RBG-47903

SUBJECT: Response to License Amendment Request to Correct a Non-Conservative  
Technical Specification Figure 3.4.11 -1 "Minimum Temperature Required vs. RCS  
Pressure" by Replacing with 54 Effective Full Power Years (EFPY) Curves NRC  
Request for Additional Information (RAI)  
River Bend Station, Unit 1  
Docket No. 50-458  
License No. NPF-47

**REQUEST FOR ADDITIONAL INFORMATION**  
**TS Figure 3.4.11-1 P/T Curves**  
**RIVER BEND STATION, UNIT 1**  
**DOCKET NO.: 50-458**

Figure 3.4.11-1 (page 1 of 1)  
 Minimum Temperature Required vs. RCS Pressure  
 Without Uncertainty for Instrumentation Error

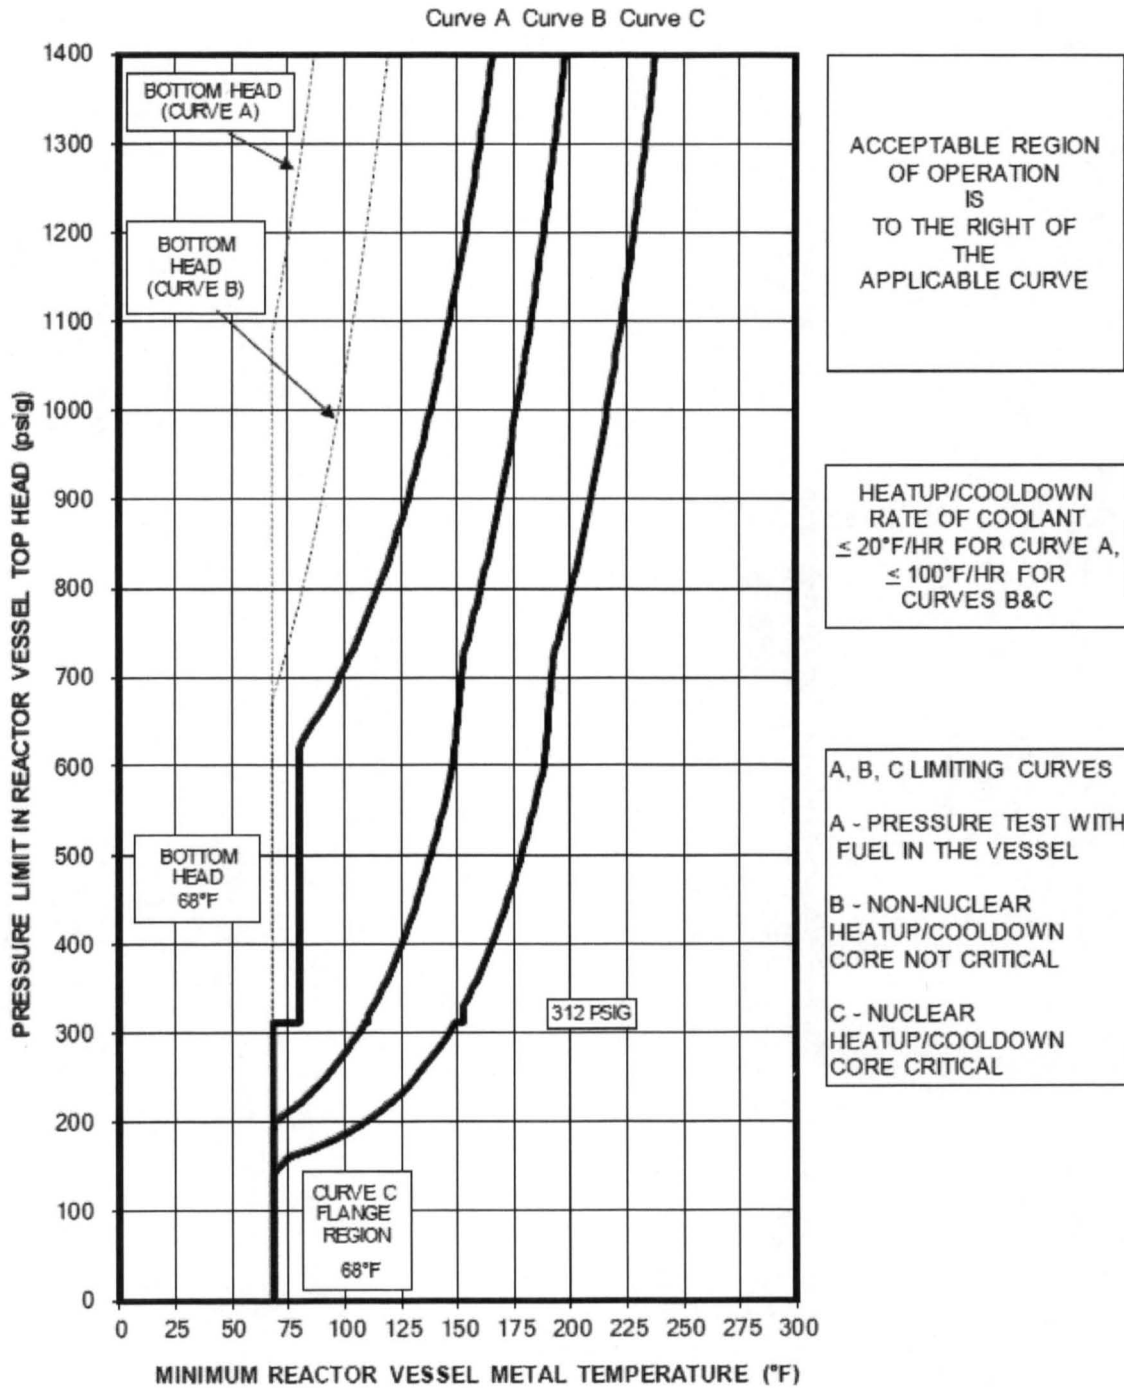
In addition to the RAI responses Enclosure 2 contains a supplement to RBG-47824 Attachment 2: Technical Specification (TS) Pages – Clean. The brackets surrounding “Without Uncertainty for Instrumentation Error” at the bottom of the page have been removed to clarify that the information is not proprietary.
